AGENDA
DESIGN COMMISSION
Community Room, 3rd Floor
Arlington Heights Village Hall, 33 S. Arlington Heights Rd.
Arlington Heights, IL 60005
March 25, 2025
6:30 PM

MINUTES OF THE VILLAGE OF ARLINGTON HEIGHTS DESIGN COMMISSION

ITEM 2. PUBLIC LAND RE-REVIEW**DC#24-101 – Arlington Heights Park District - Recreation Park Bathhouse & Community Building – 500 E. Miner St.**

It is recommended that the Design Commission require revisions to the proposed architectural design for the new (teardown) single-family home to be located at 1006 N. Evergreen Avenue. This recommendation is based on the architectural plans received 3/3/25, Design Commission recommendations, compliance with all applicable Federal, State, and Village codes regulations and policies, the issuance of all required permits, and the following:

NEW HOUSE AT 1006 N EVERGREEN AVE

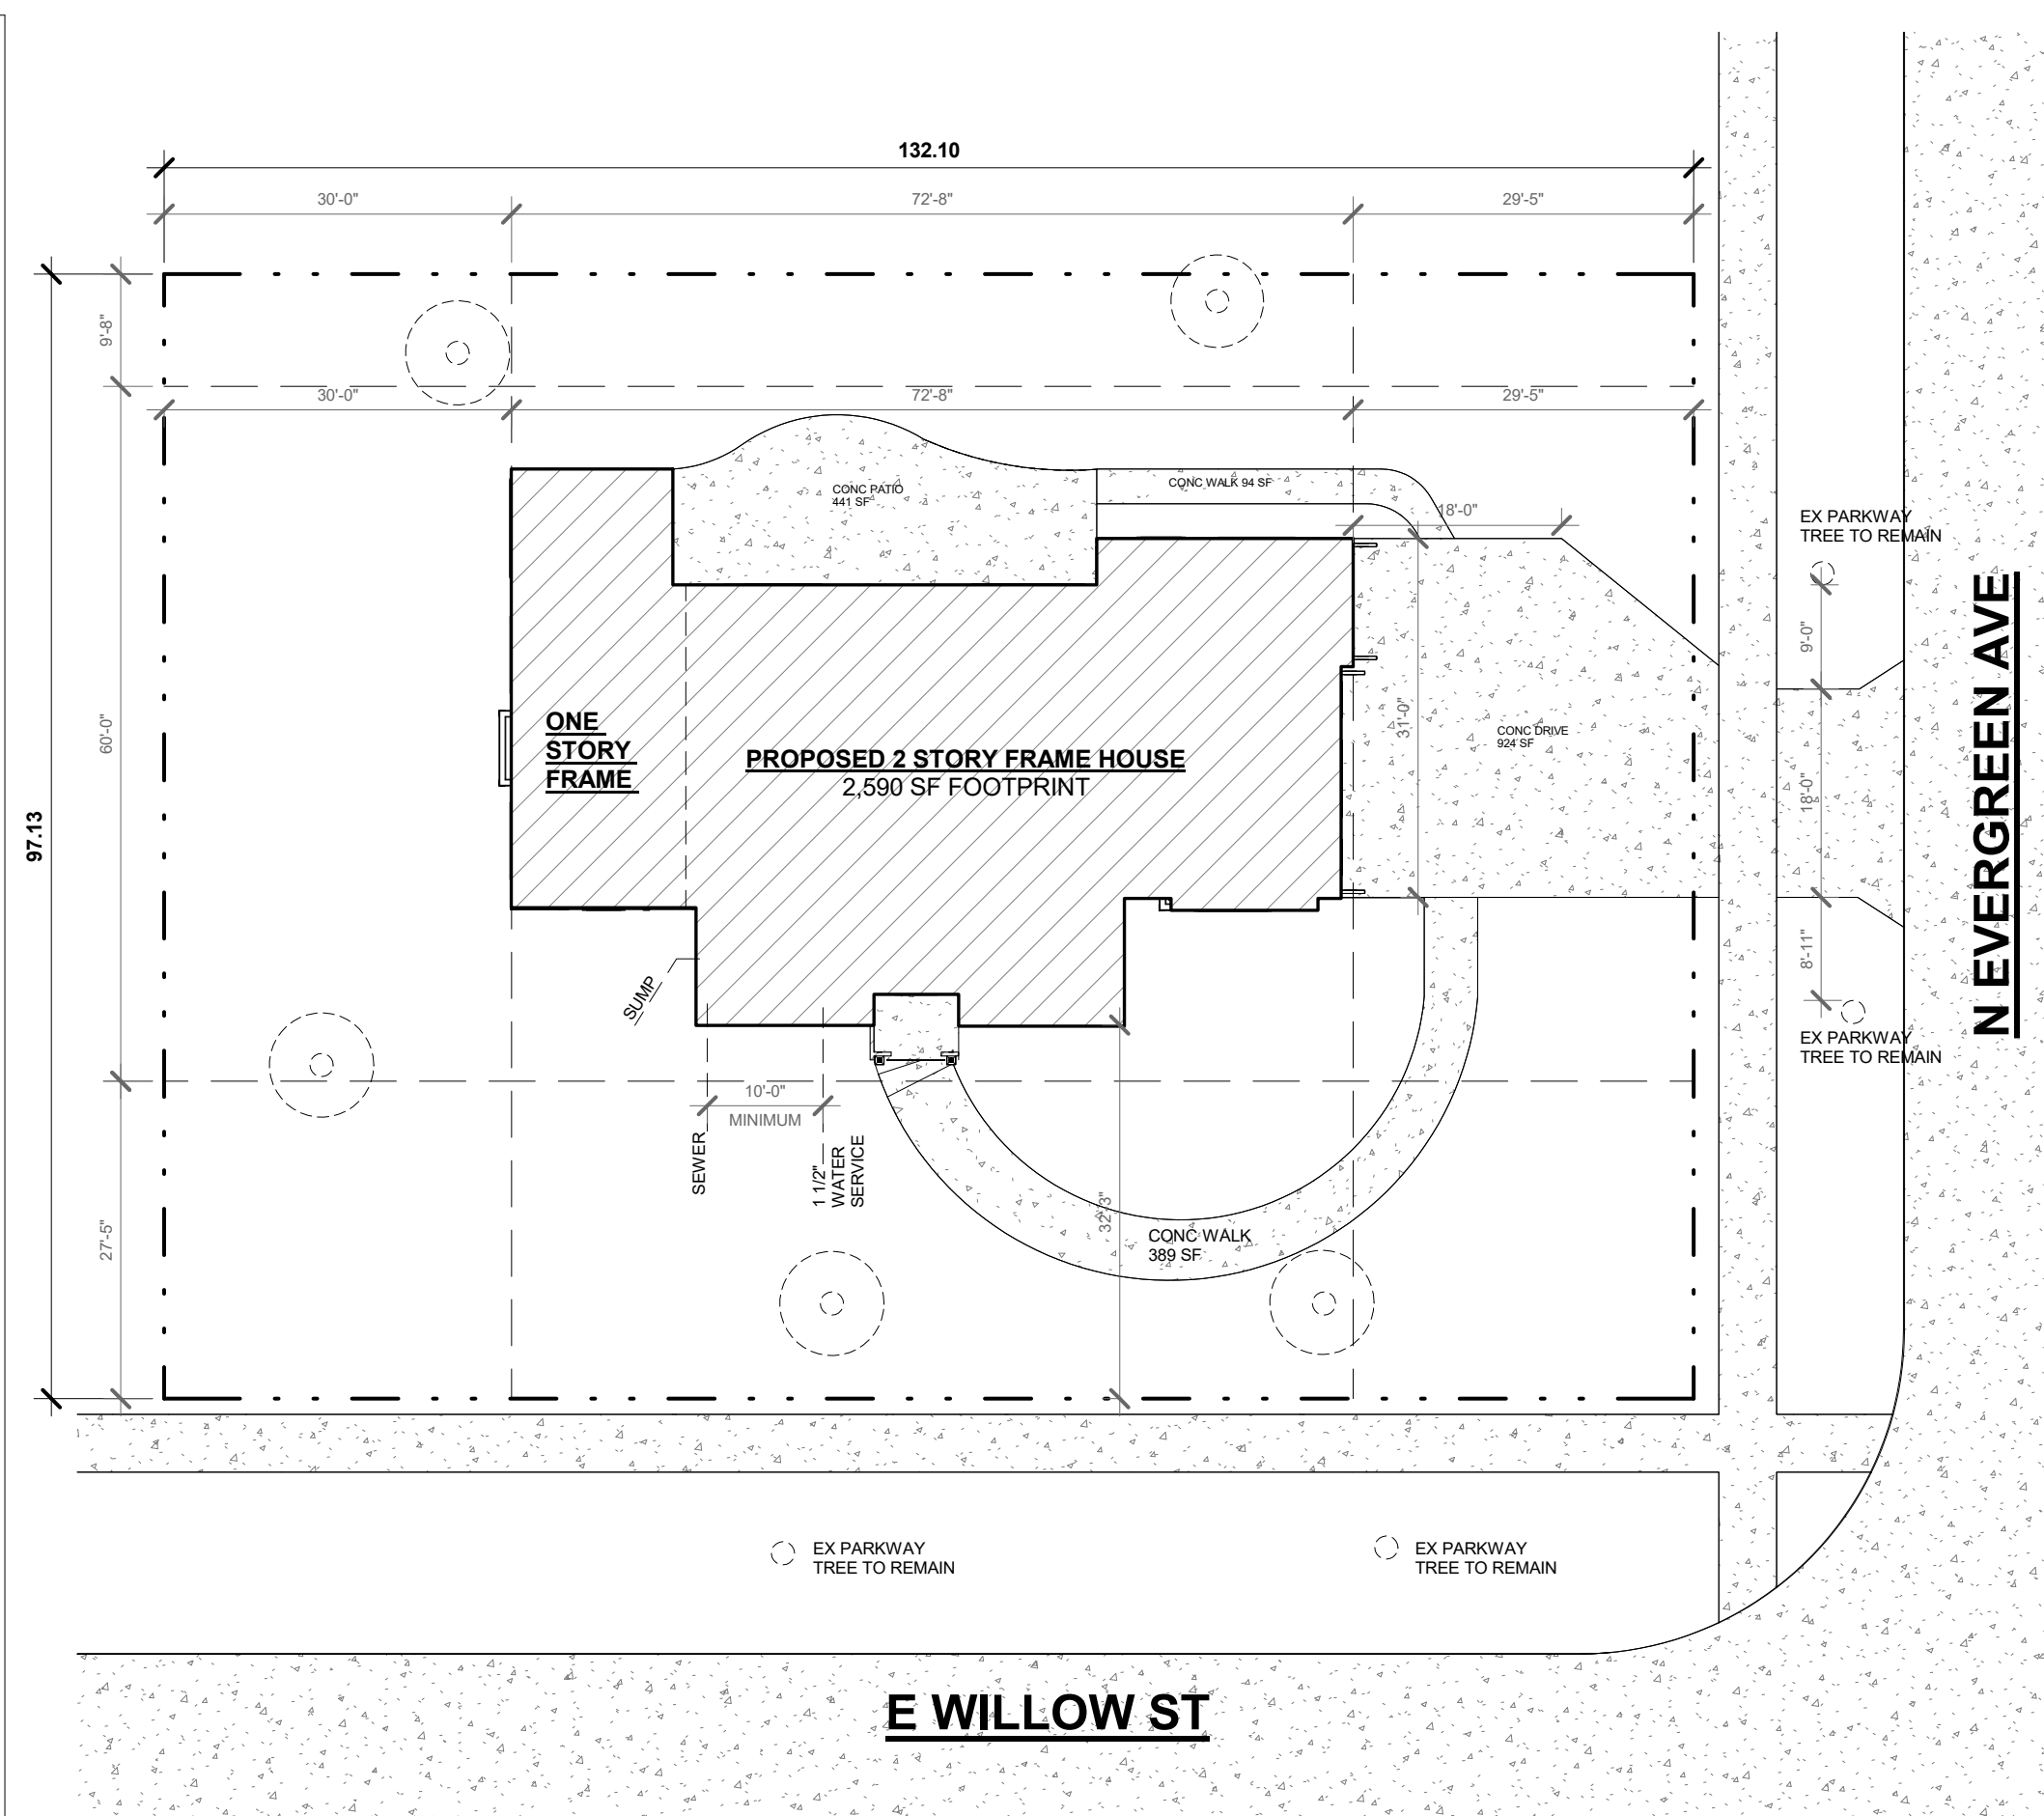
1. Either redesign the house, or flip the floor plan on the site, to move the garage to the rear (west end) of the property.
2. This review deals with architectural design only and should not be construed to be an approval of, or to have any other impact on, any other zoning and/or land use issues or decisions that stem from zoning, building, signage or any other reviews. In addition to the normal technical review, permit drawings will be reviewed for consistency with the Design Commission and any other Commission or Board approval conditions. It is the architect/homeowner/builder's responsibility to comply with the Design Commission approval and ensure that building permit plans comply with all zoning code, building permit and signage requirements.
3. Compliance with all applicable Federal, State, and Village codes, regulations and policies.
